From: Stephen Meer, P.E. <smeer@thesigmagroup.com>
Sent: Thursday, May 20, 2021 8:52 AM
To: Michalets, Linda M - DNR; Eric Ogden
Cc: Joshua Neudorfer; Sean Flanagan (sflanagan@hsacommercial.com)
Subject: RE: Former Biogenesis site work plan review letter
Attachments: 16366 Figure 6 proposed well map 2rev011321.pdf; Vapor Data Table 16366.pdf

FORMER BIOGENESIS
 610 W. RAWSON AVENUE
 OAK CREEK, WISCONSIN

Proposed Well Locations

Figure 6

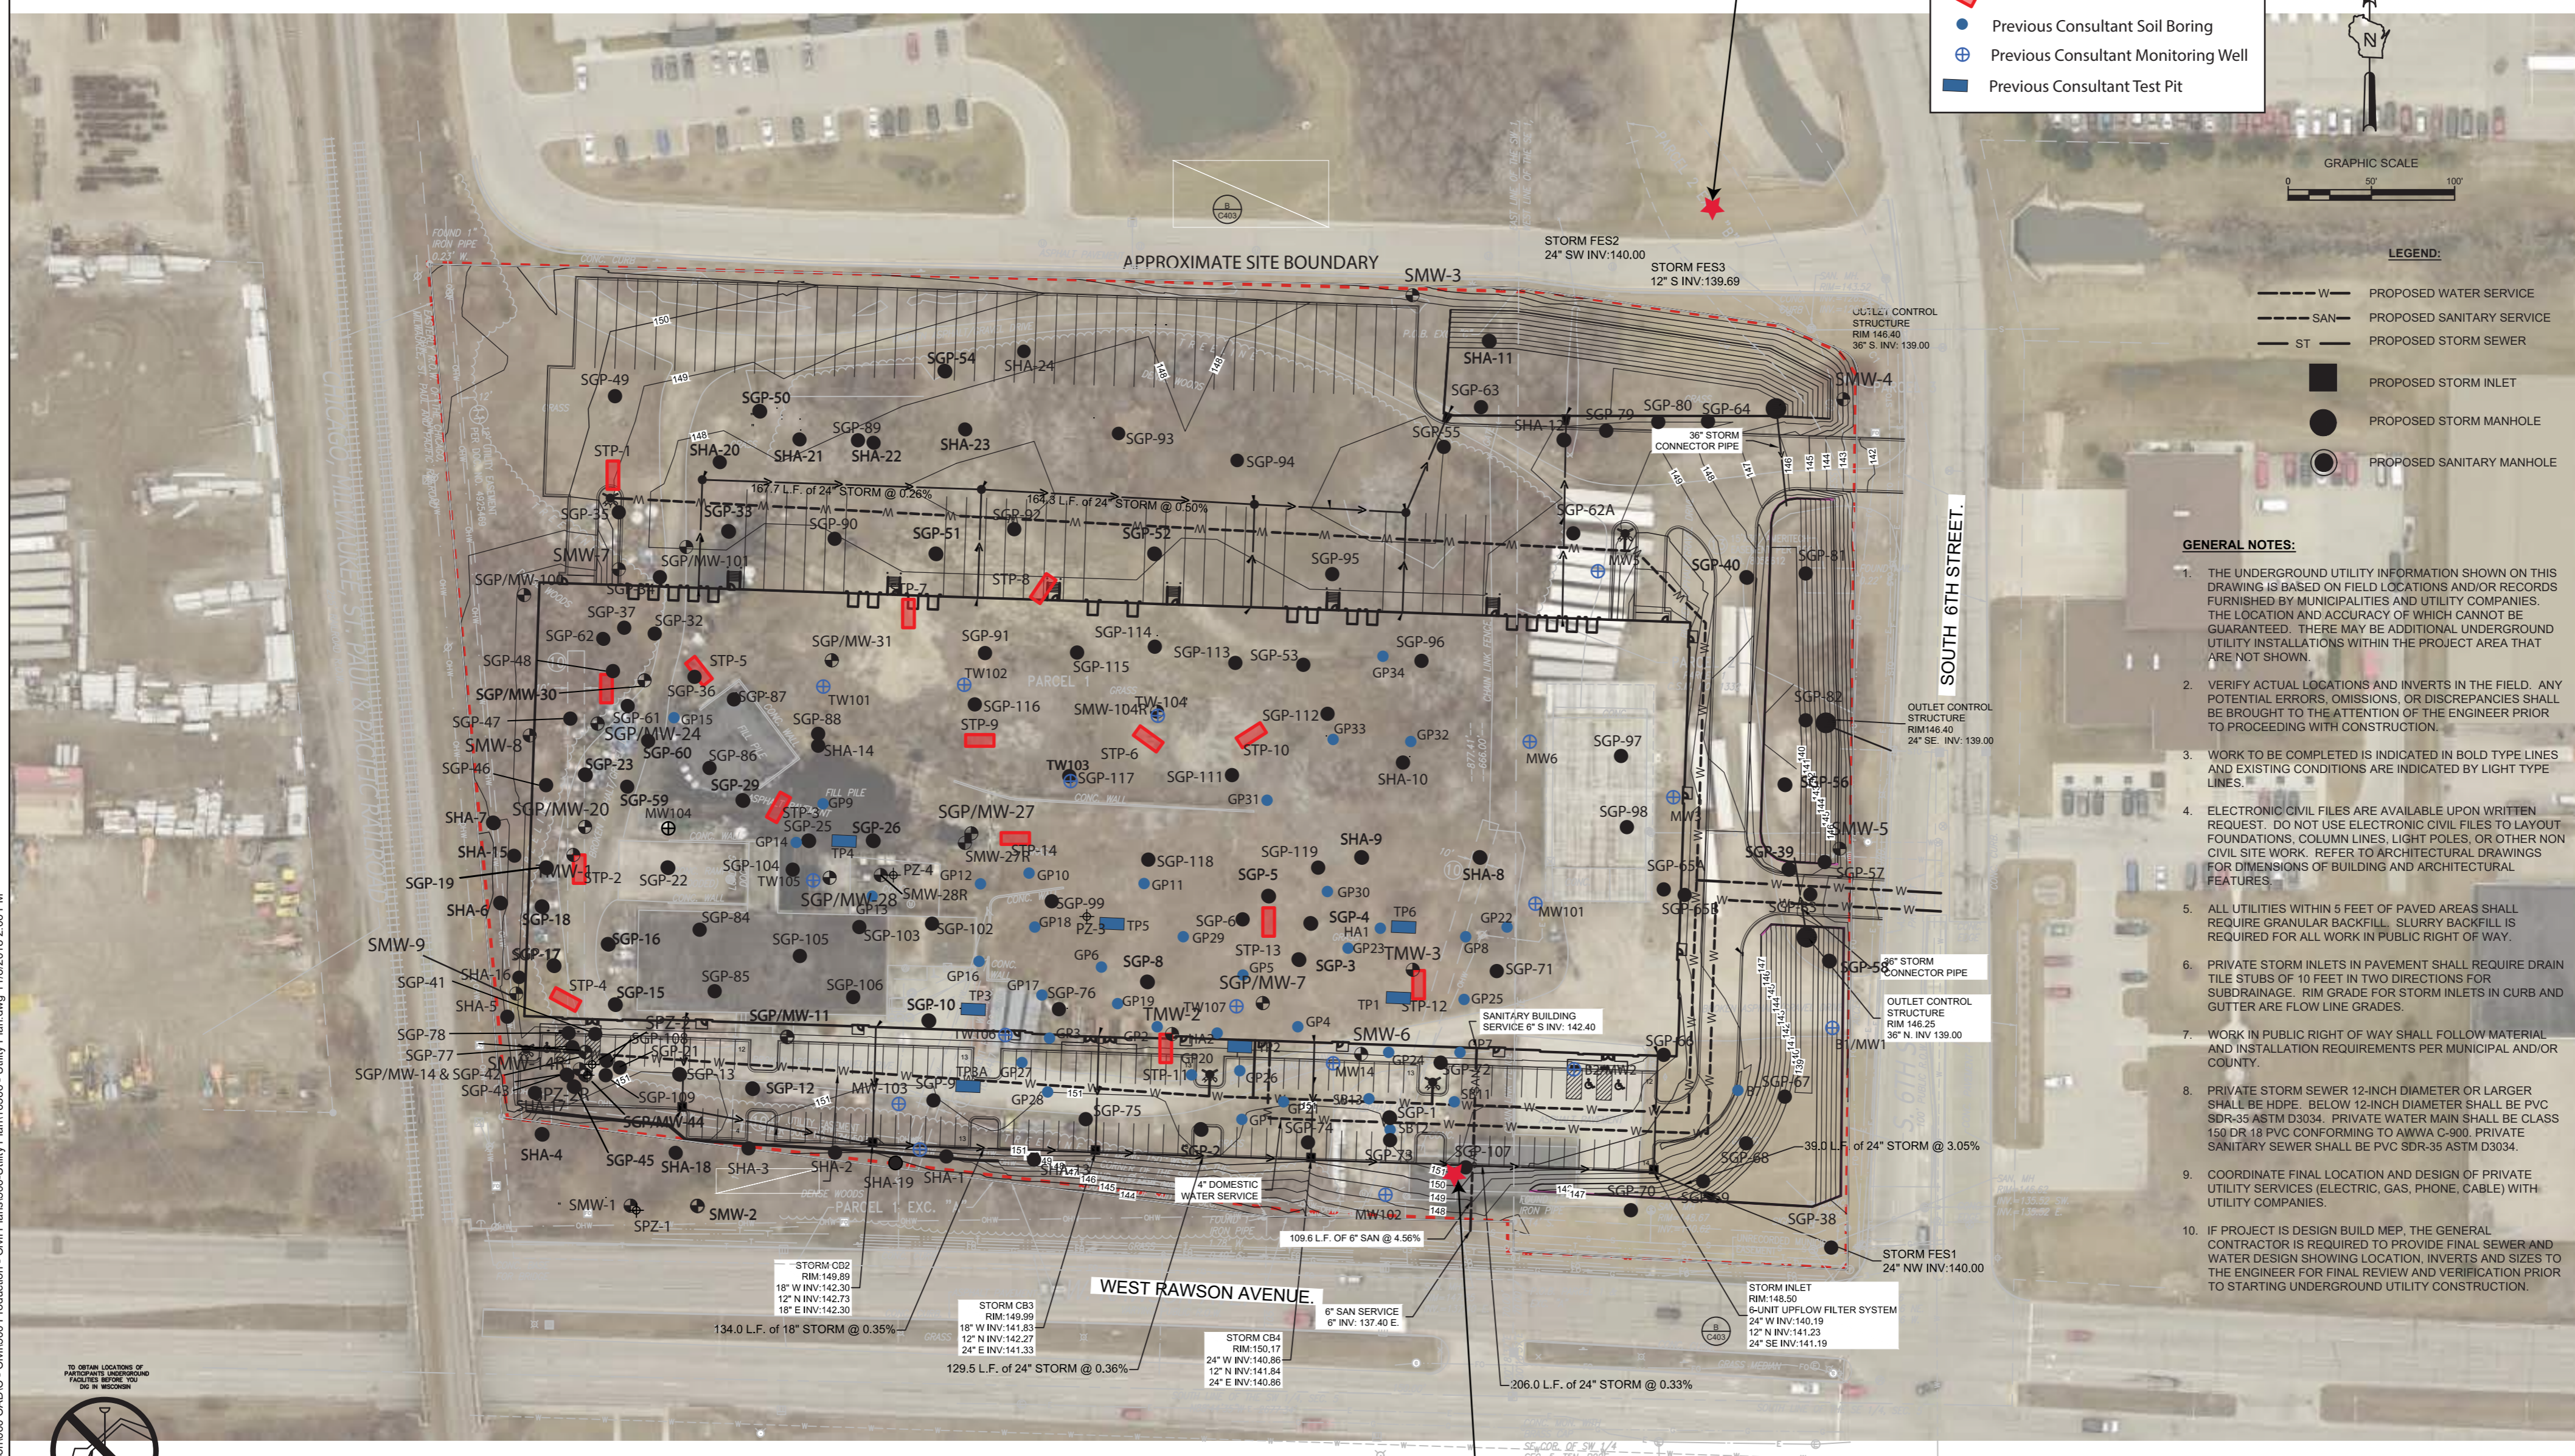
Sigma and Oak Creek Rawson Industrial acknowledge the Department's request for the collection of additional soil samples for laboratory analysis of PFAS. Based on that request, in addition to the proposed soil sample collection as part of the additional groundwater monitoring well to be installed in the right-of-way to the northeast of the site, collection of a soil sample for laboratory analysis of PFAS from the boring associated with the proposed additional groundwater monitoring well location to the southeast of well SMW-6 will be incorporated into the proposed scope of work (additional proposed well locations are illustrated on the attached **Figure 6**). The soil sample from the southeast well location will be collected at a depth representative of soil undisturbed during site redevelopment (approximately 3 feet below current grade). Prior to development of a plan for additional soil sampling for PFAS beyond the location of the two additional groundwater monitoring wells, Sigma recommends collecting additional groundwater data, consistent with the scope proposed in the December 2020 work plan (including laboratory analysis for the Wisconsin list of 33 constituents).

Therefore, Oak Creek Rawson Industrial is notifying the Department of our intention to proceed with the scope of work recommended in the December 2020 work plan with the additional soil sampling at the southeast groundwater monitoring well as discussed above. Following completion of the additional investigation a report providing the additional results and recommendations based on those results will be provided to the Department.
